Technical Bulletin

Models: Red Dragon PSD

Subject: New Wide Exit Chute

Figure 1 - The original chute (005119) is shown on the left and the new chute (011757) is shown on the right

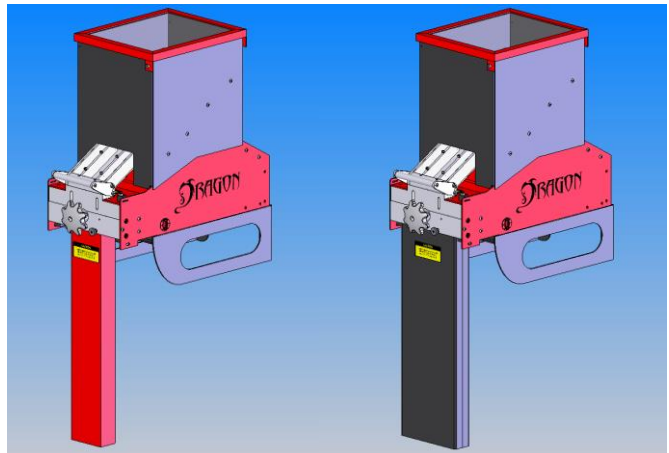
A new exit chute has been developed for the Red Dragon Plastic Sphere Dispenser (PSD). The new chute extends the width of the machine in order to catch any glycol or permanganate that may have accumulated at the injection head. There are no significant performance or safety concerns associated with using the original chute. Several of the new chutes have been trialled with positive results. All new Red Dragon PSDs will include the new wide chute.

The new chute is easily distinguished from the original chute by its width and colour (see Figure 1). The new chute will have the same black finish as the hopper, while the original chute is red. No modification to the machine is required to install the new chute.

SEI will sell the new chute as part 011757 (CHUTE,EXIT,WIDE,ASSY) for customers who would like to upgrade their machines. The original chute 005119 (CHUTE,OUTLET,ASSY) will no longer be available for purchase.
